VOLVO CAR
SERVICE AND PARTS BUSINESS

Technical Journal

T8 P0EA773 Auxiliary Cooling System Performance

REF NO:	ISSUING DEPARTMENT:	CAR MARKET:	
TJ 34123.1.2	Technical Service	United States and Canada	
PARTNER:		ISSUE DATE:	STATUS DATE:
3 US 7510 Volvo Car USA		2018-09-27	2018-10-19
FUNC GROUP:	FUNC DESC:	Page 1 of 3	
2647	Heater, thermostat

File Name	File Size
US34123_Orientation_Illustration.JPG	0.0363 MB

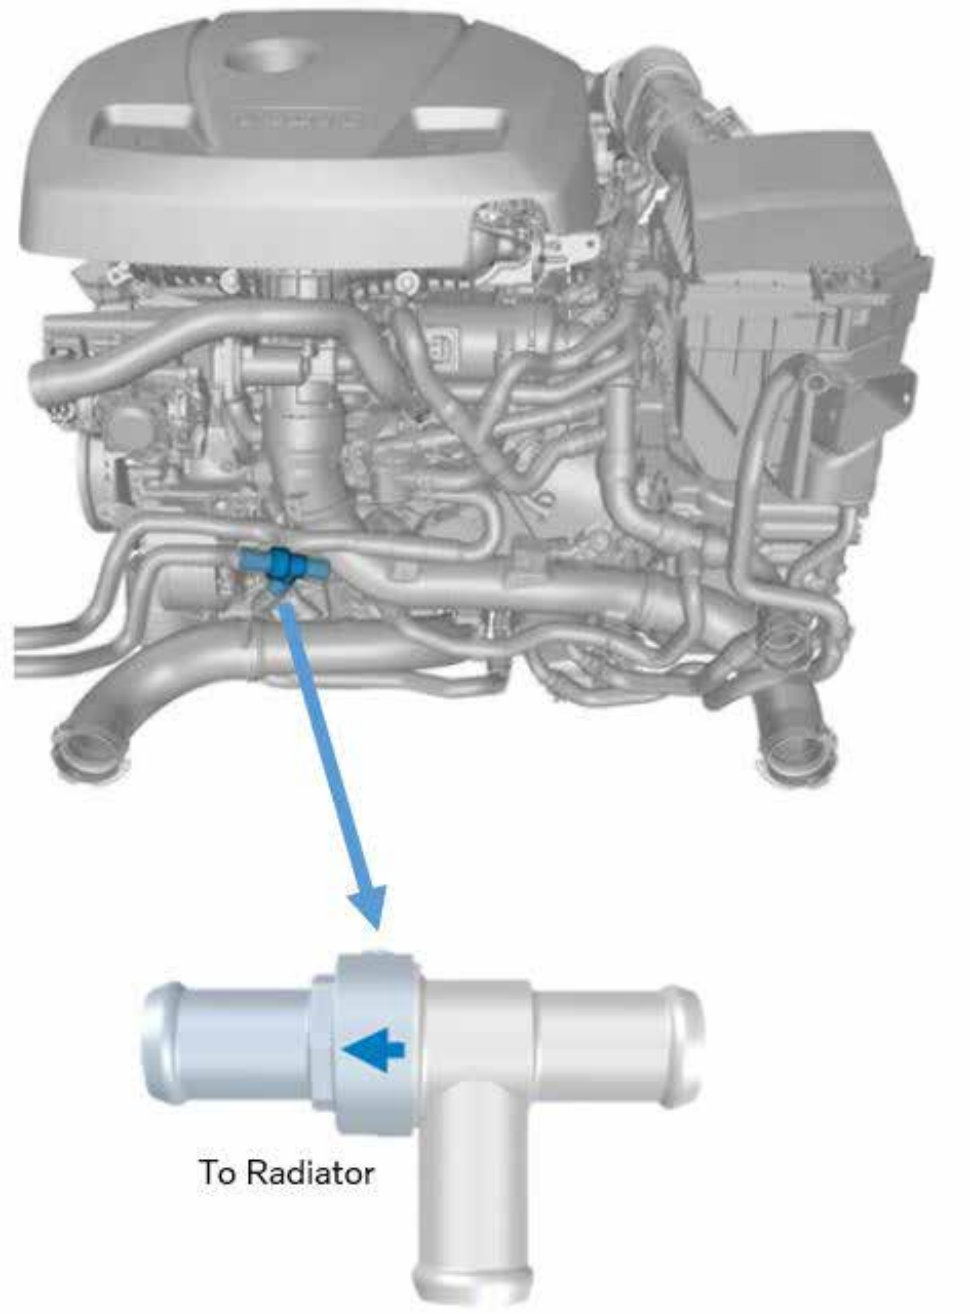
SERVICE:
A new component is now available for replacement and the old thermostat part number has been blocked.

To install the new component, please follow instructions under Information -> Removal, replacement and installation -> Engine with mountings and equipment - Cooling system -> Coolant pump and thermostat -> ERAD cooling system thermostat.
Note: Orientation of the component is critical to correct operation. See attached photo US34123_ Orientation_Illustration.jpg
